### **Addendum #3: Q&A Published 6/25/2026**

This information is related to Bartow County's Parks and Recreation Archery Range and 3D Archery Trail

**BARTOW COUNTY-ARCHERY RANGE AND 3D ARCHERY TRAIL**

**BARTOW ARCHERY RANGE**

DRAWN BY CH	CHECKED BY KAK
SCALE 1"=60	ISSUE DATE 4/30/2026
PROJECT NUMBER 2134.015	
DRAWING NUMBER <b>C-300</b>	
SHEET 6 OF 23

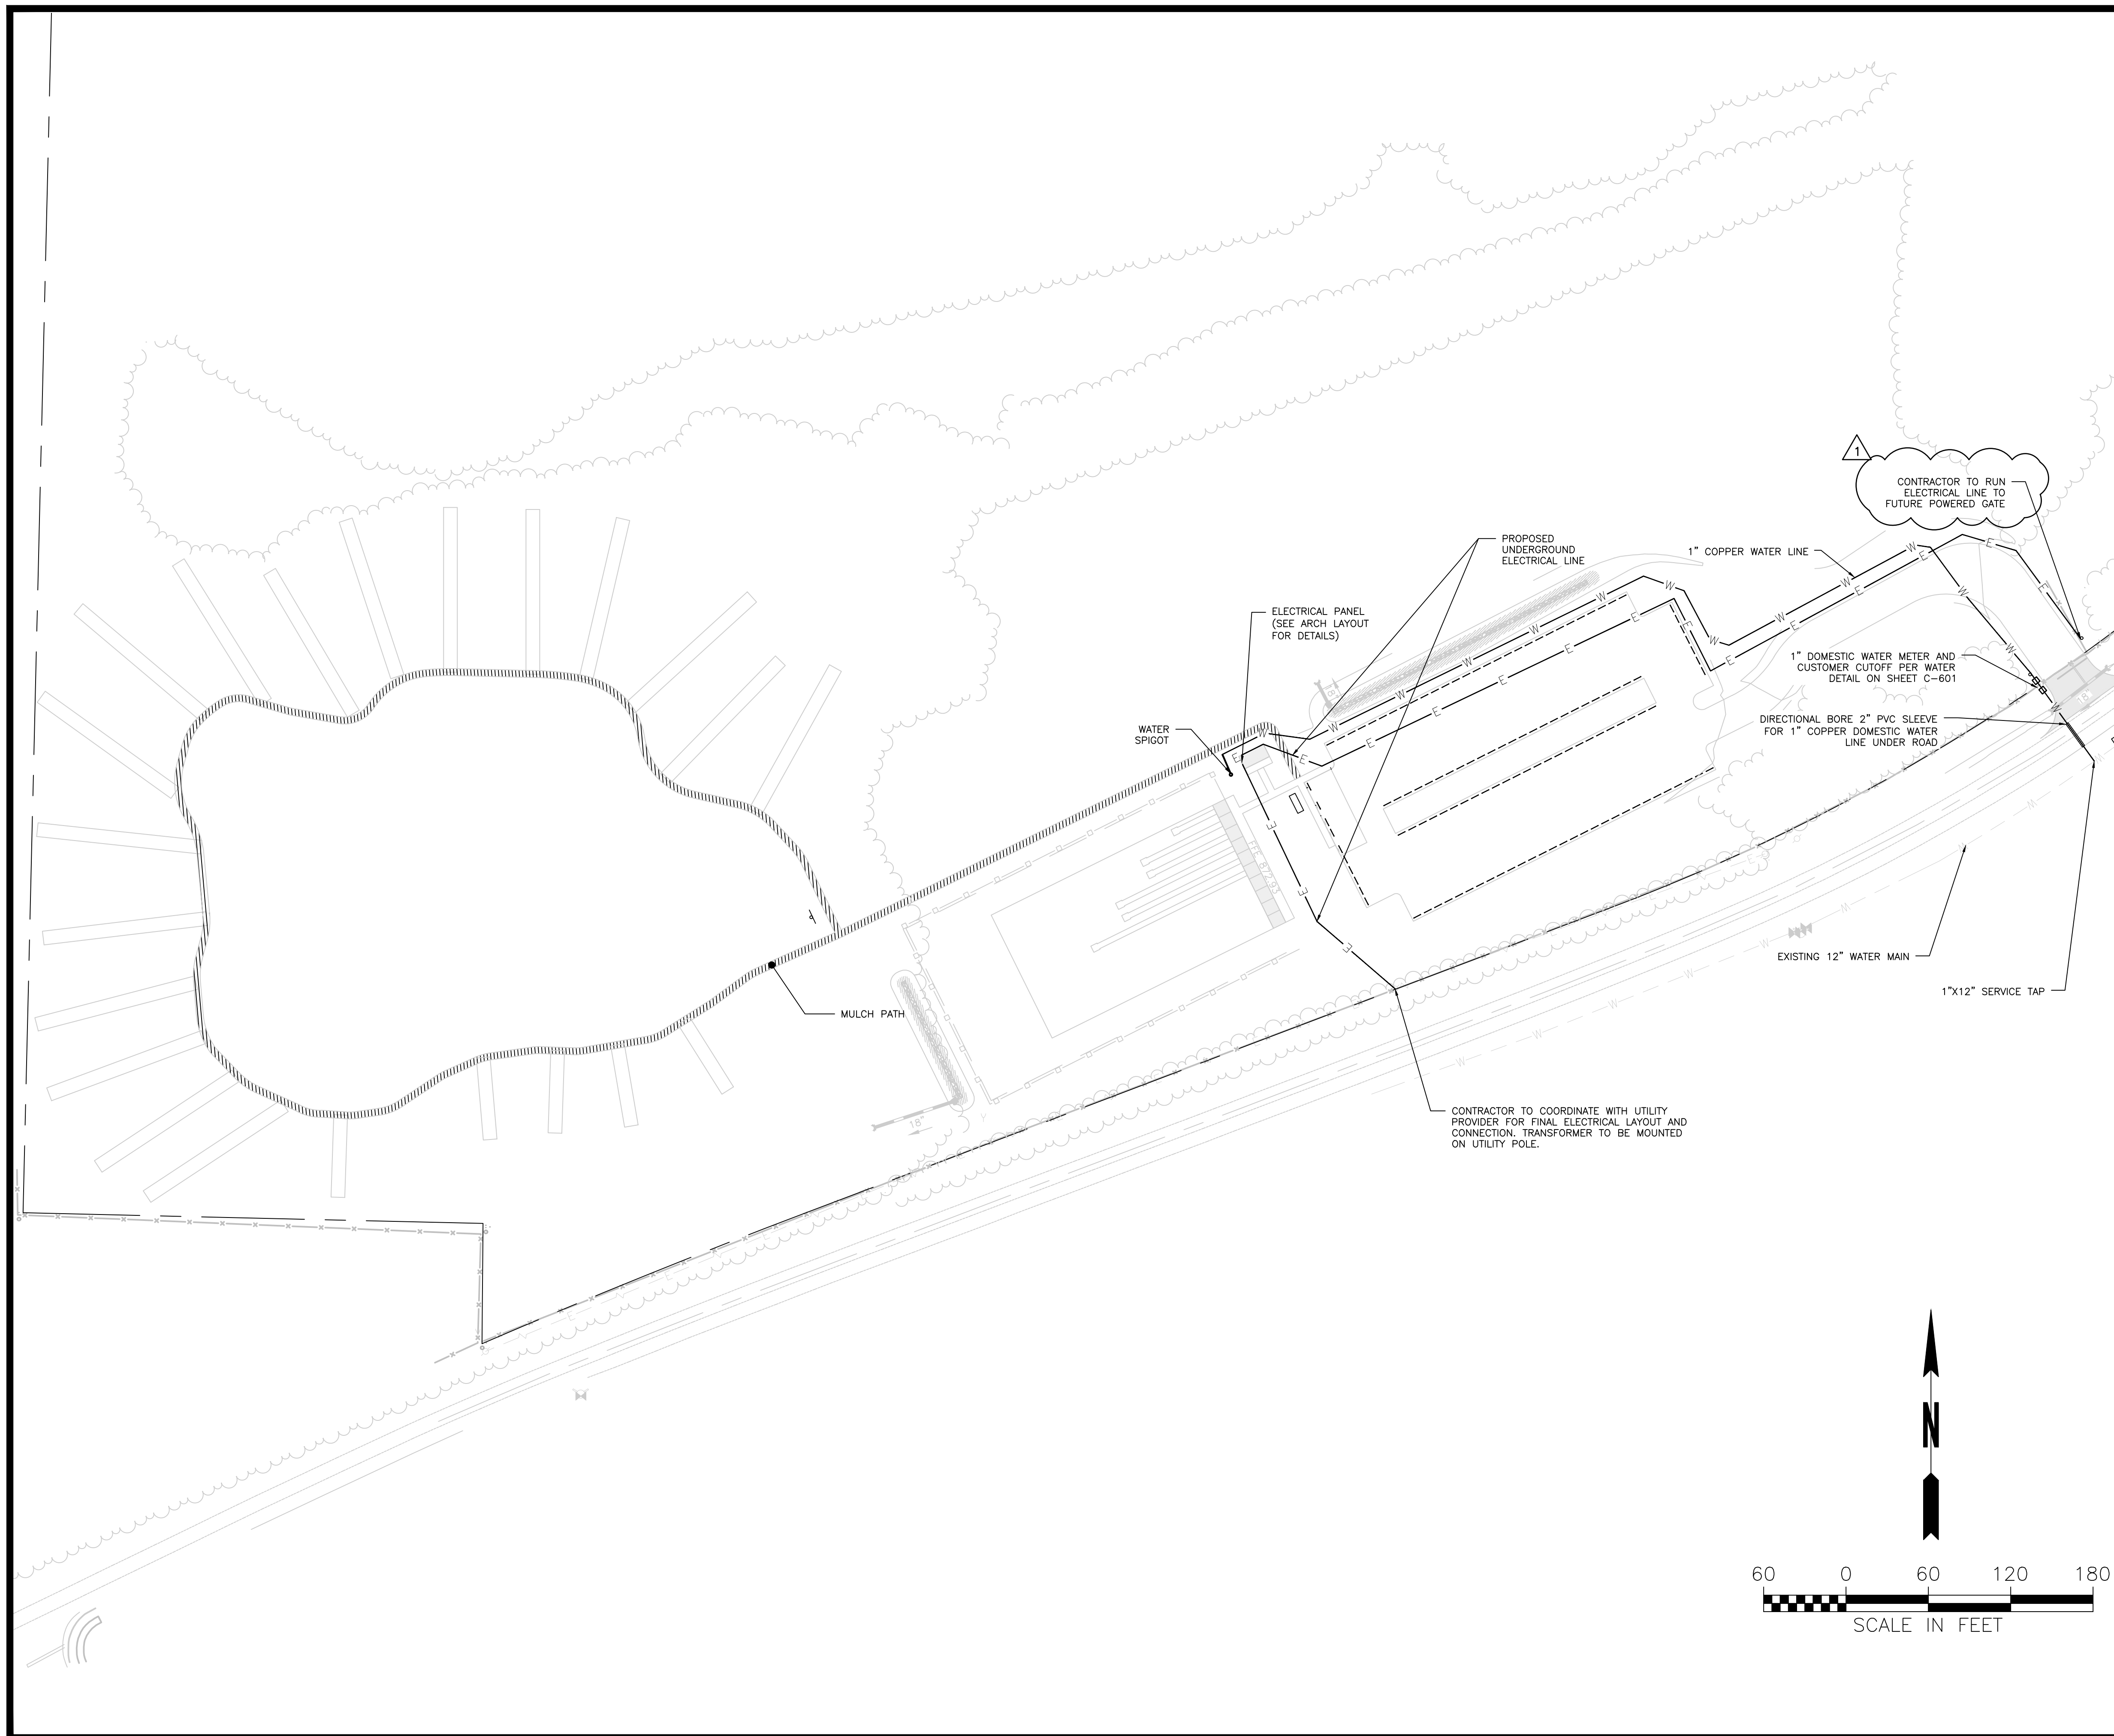
Q. Do you want the post and rail fence to be 5' tall (C-300) or shorter per the detail on C-600.

a. Fence will be per detail on sheet C-600. See updated plans included with Addendum #3.

**C-504**  
 SHEET 13 OF 23

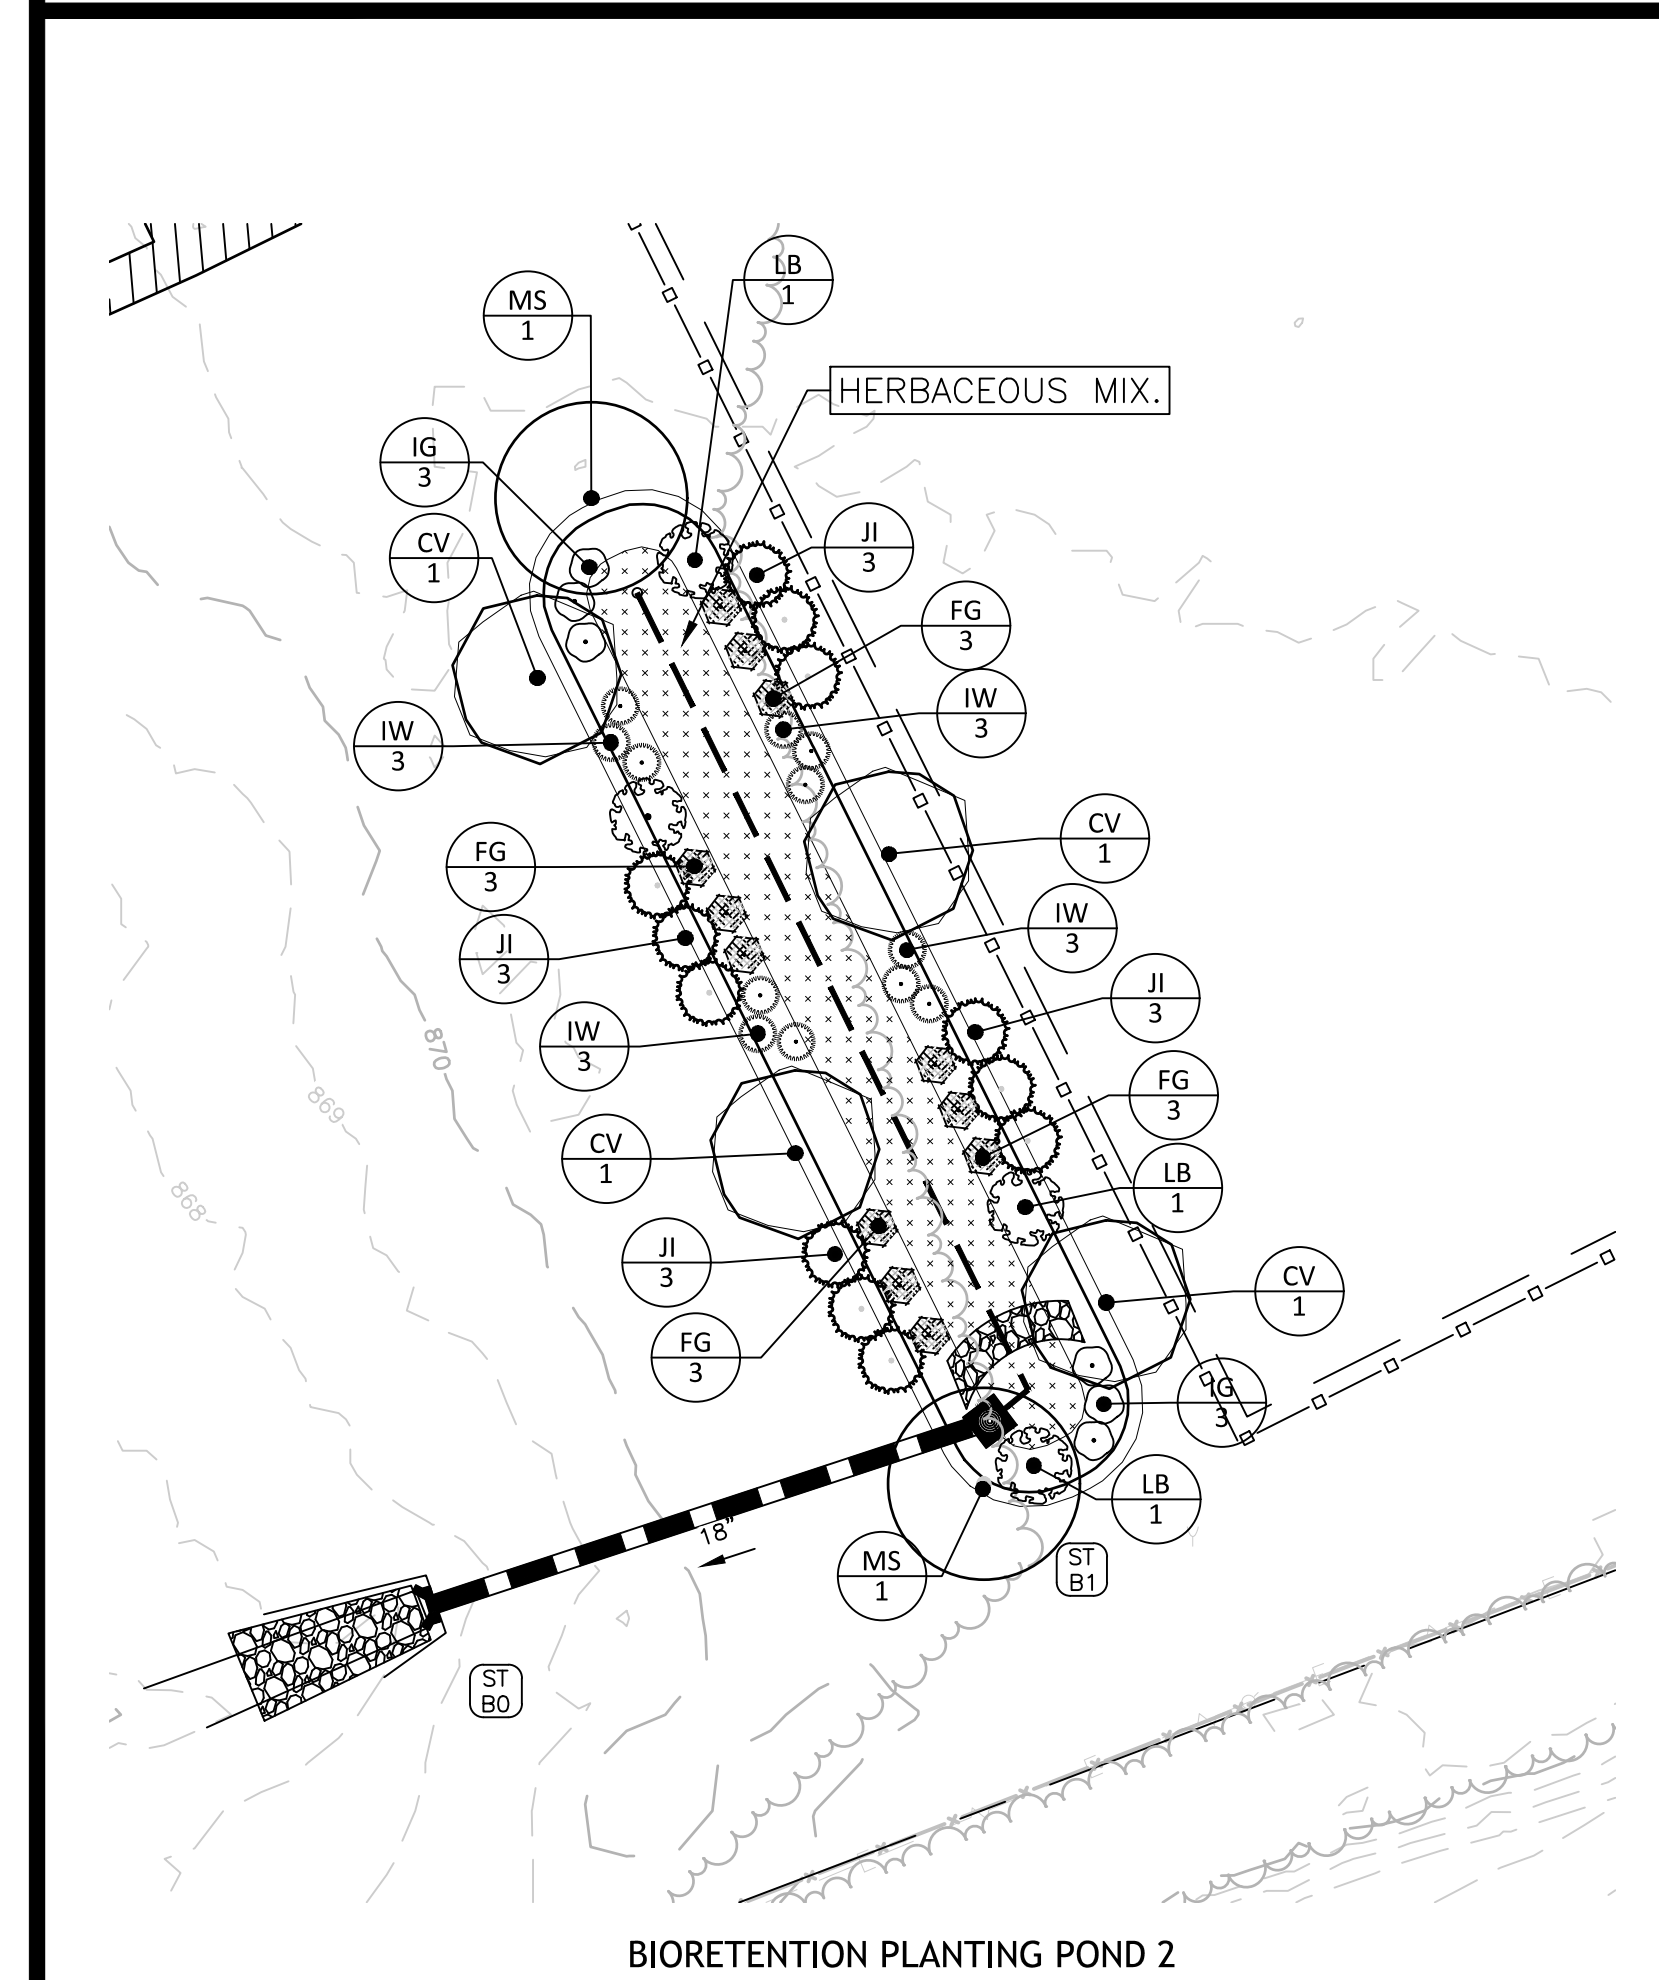
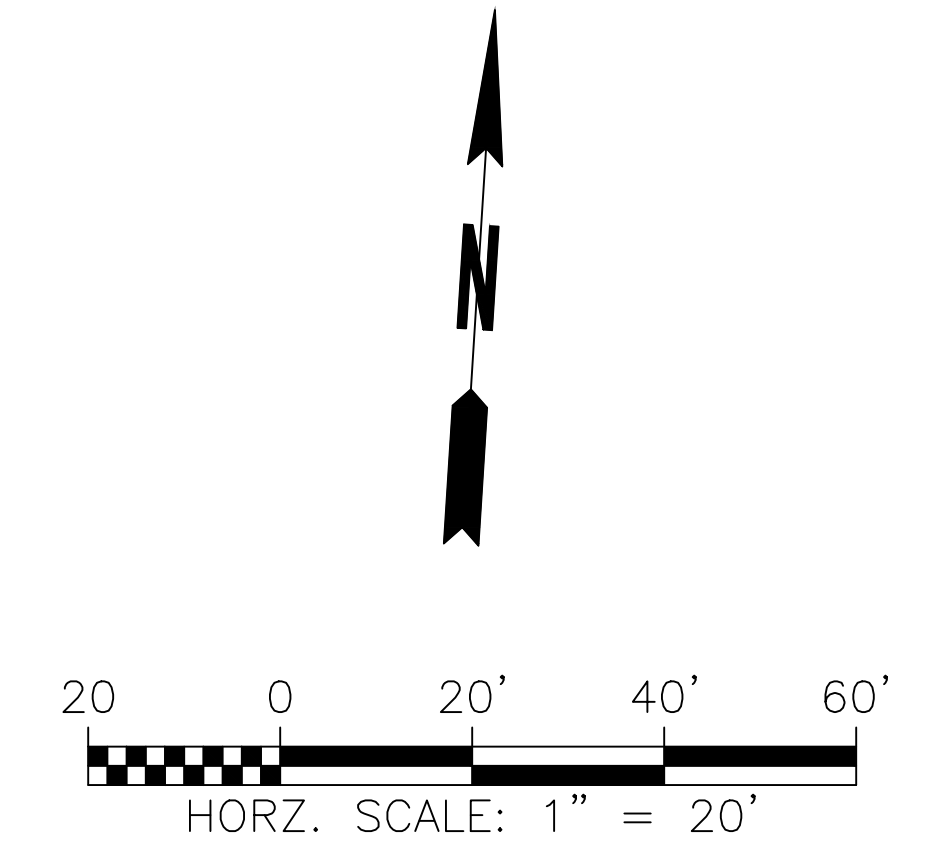
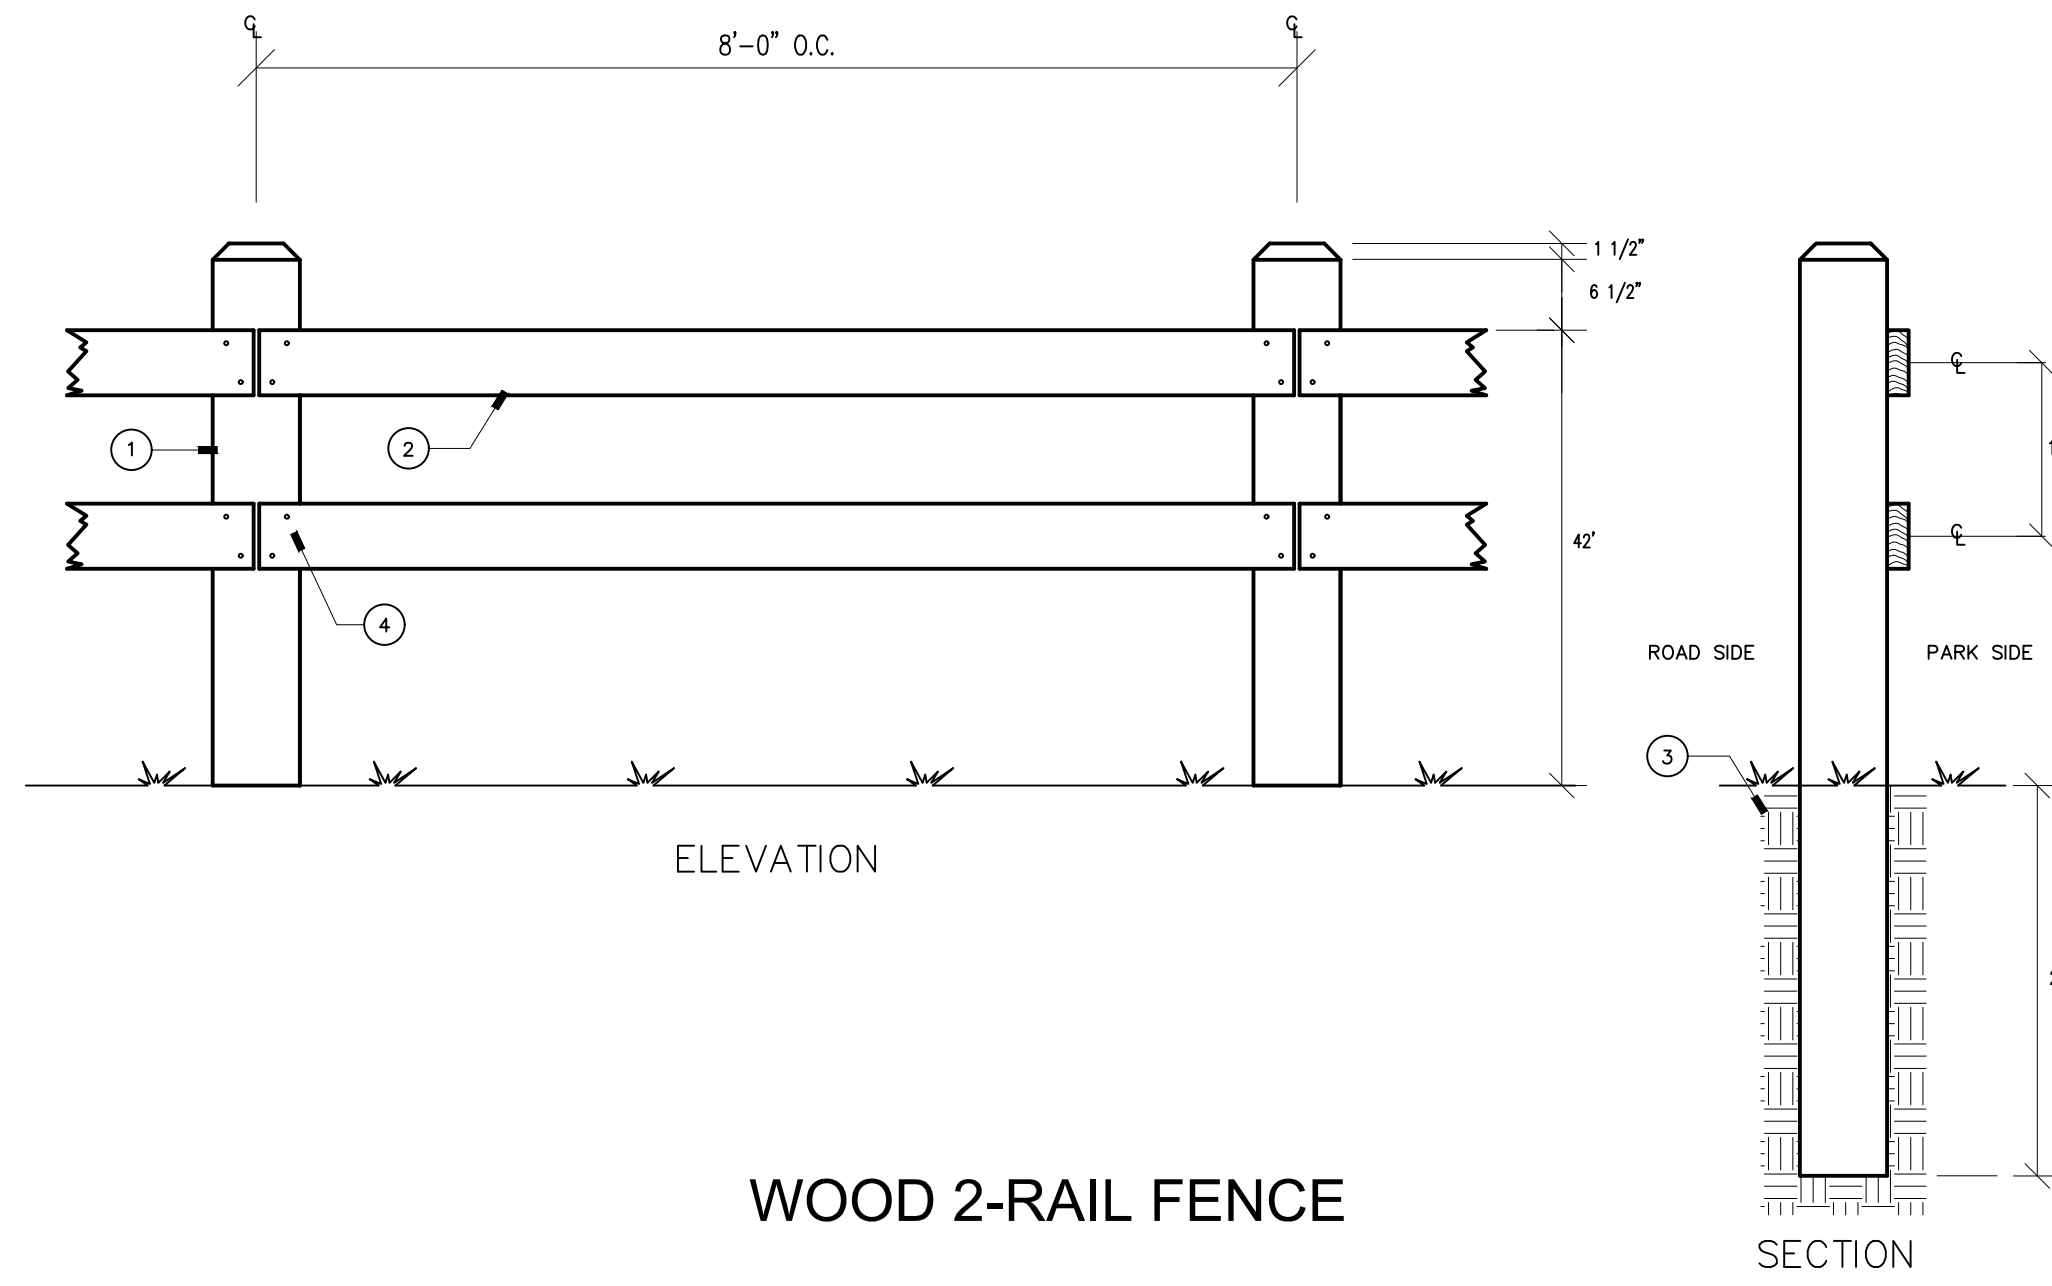
Q. Bio Ponds have no detail on what landscaping is to be installed. Can you provide a landscape plan?

a. Bioretention Planting Plan has been added to the plans sheet C-504.
